BOROUGH OF OCEANPORT

PLANNING/ZONING BOARD

AGENDA • DECEMBER 14, 2021

1. PB2020-21 Somerset Lodging Parcel - Approval of Street Names
2. PR-21-33 Resolution of Approval - Oport Partners, Phase II
3. PB2021-13 SCHMIDT, WILLIAM W.

PROPOSED CONDITIONS

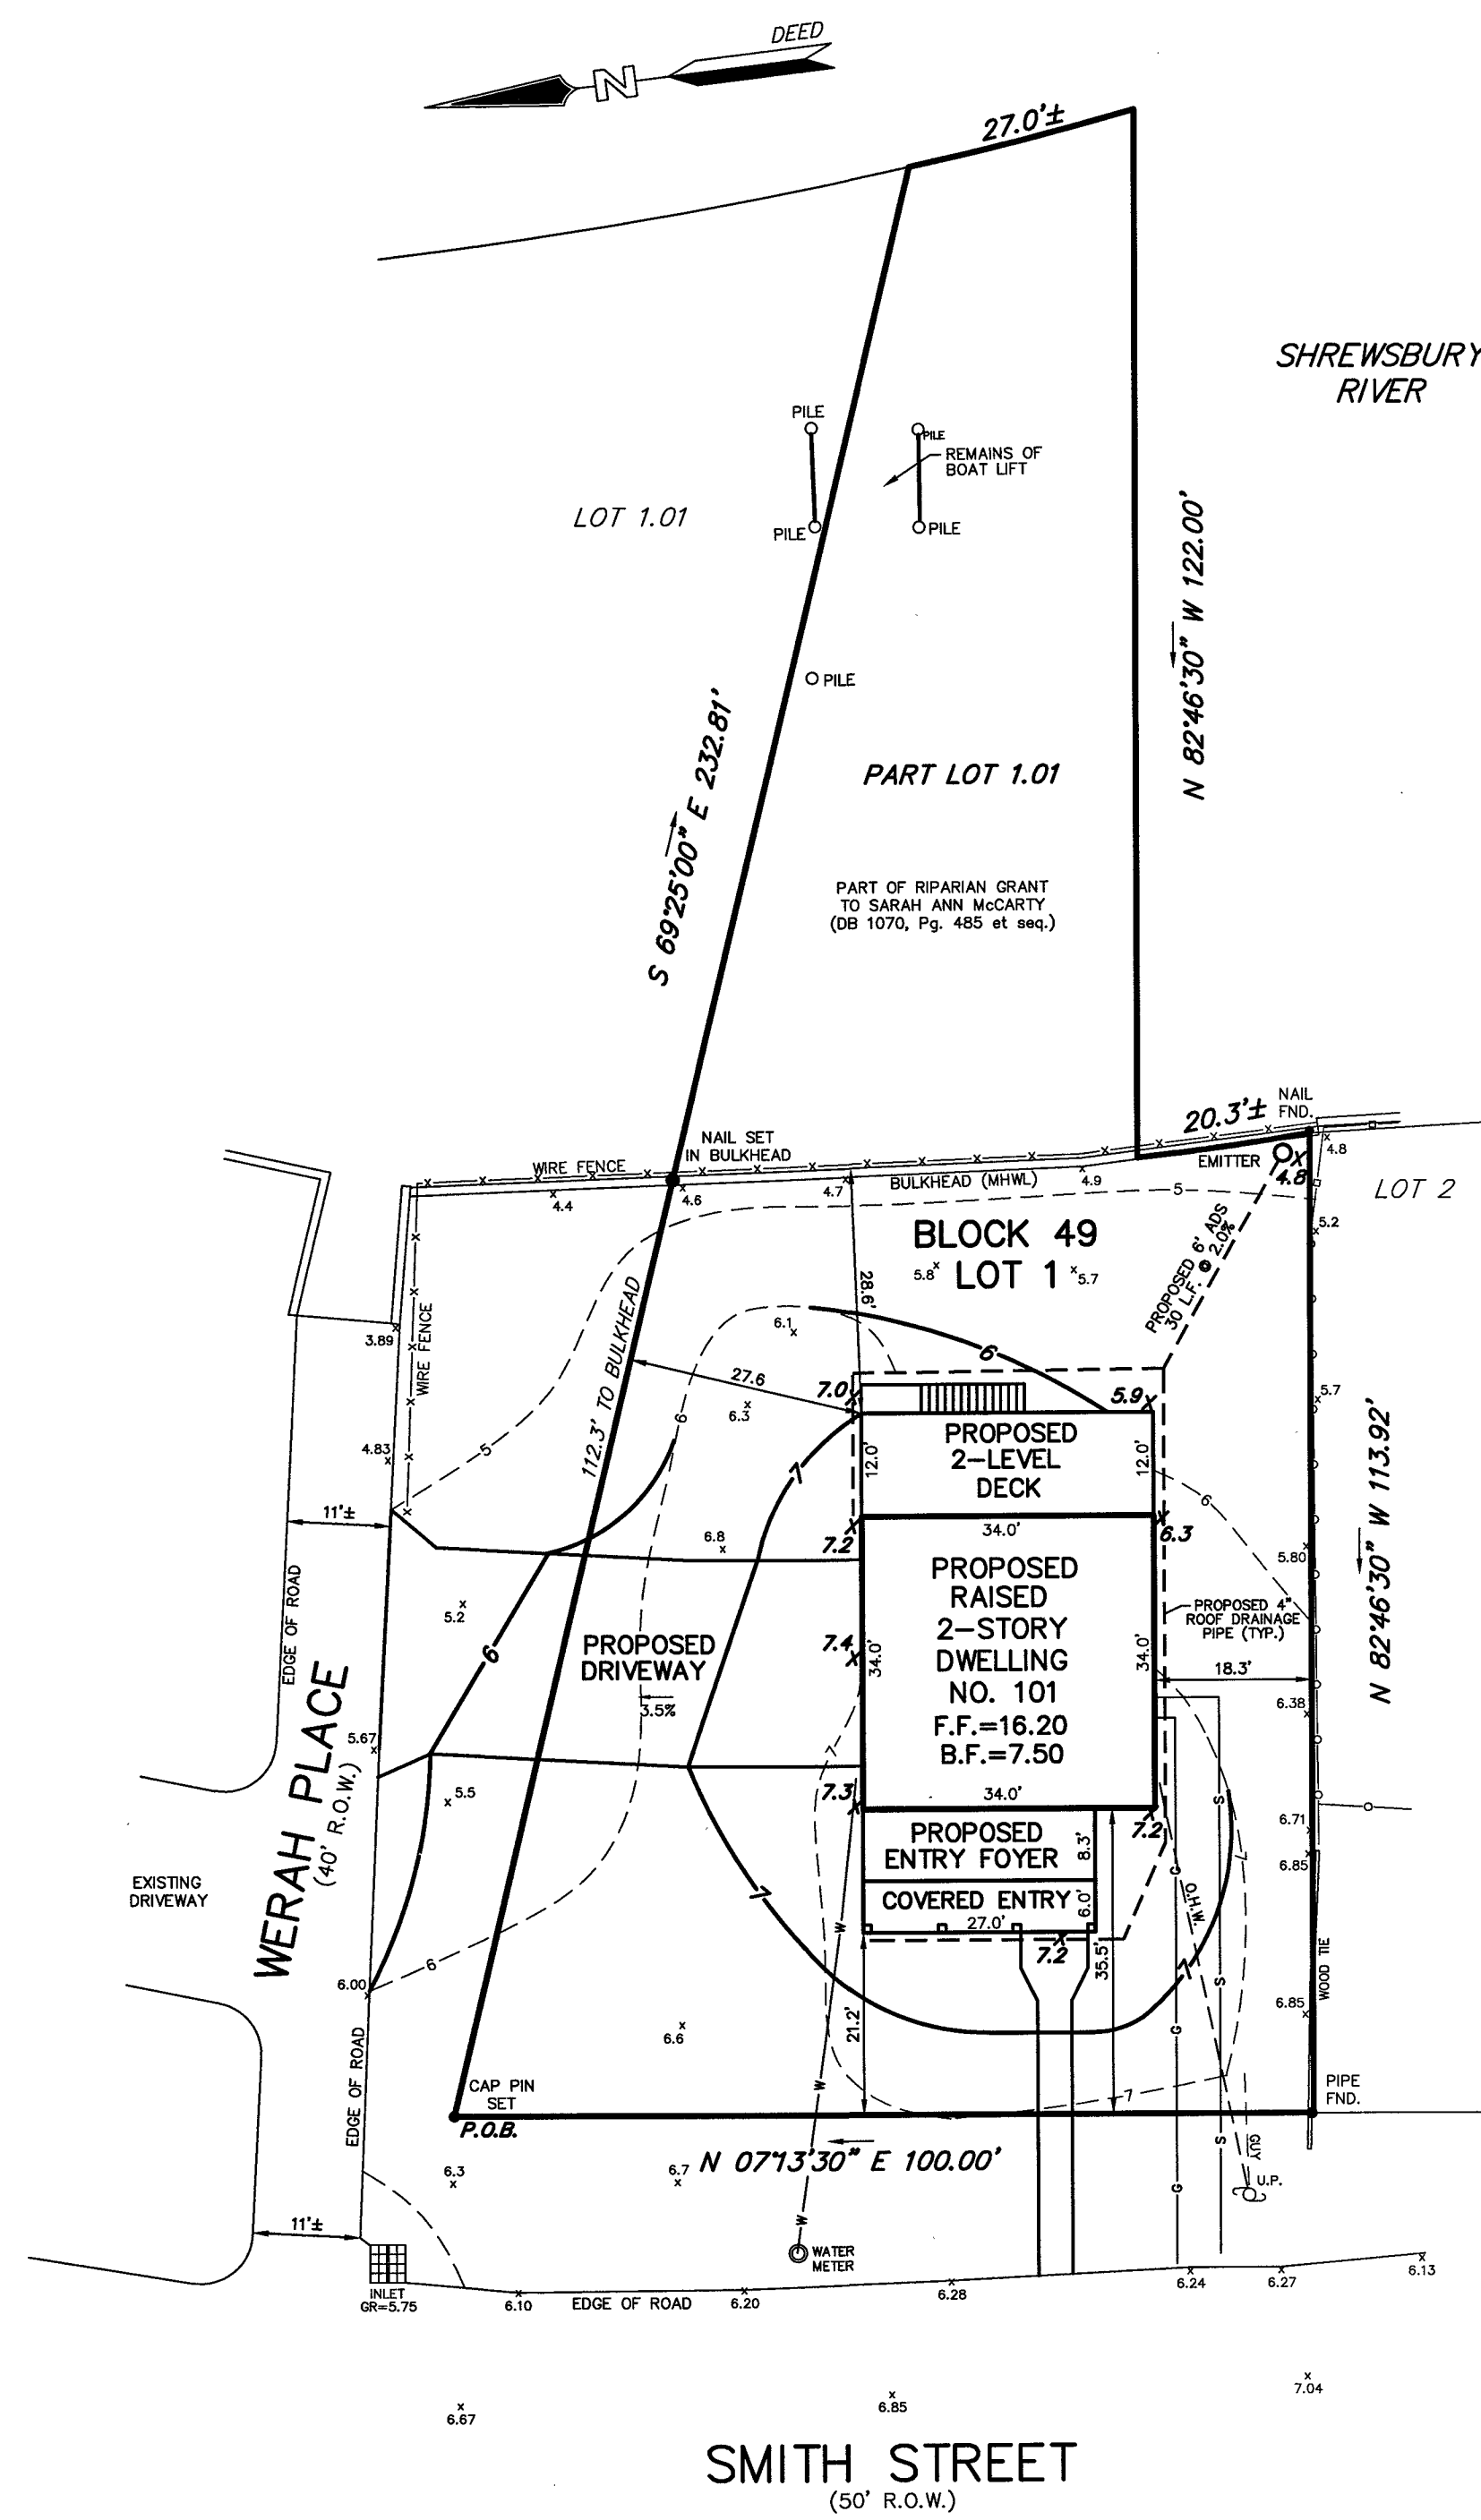
2	12-01-21	PER BOARD COMMENTS AT NOVEMBER HEARING & BOARD ENGINEER'S REPORT OF 09-16-21
1	07-11-21	PER COMPLETENESS CHECKLIST
NO.	DATE	DESCRIPTION
PLOT/GRADING PLAN		
101 SMITH STREET LOT 1 & PART OF LOT 1.01 BLOCK 49		
BOROUGH OF OCEANPORT MONMOUTH COUNTY		NEW JERSEY
Charles Surmonte P.E. & P.L.S. New Jersey Professional Engineer and Professional Land Surveyor License No. 3589		301 Main Street, 2nd Floor Allentown, New Jersey, 07711 Phone 732-660-0606 Fax 732-660-0404
PROJECT No.	DATE:	SCALE:
20-1496	02-18-21	1"=20'
SHEET:		1 OF 1
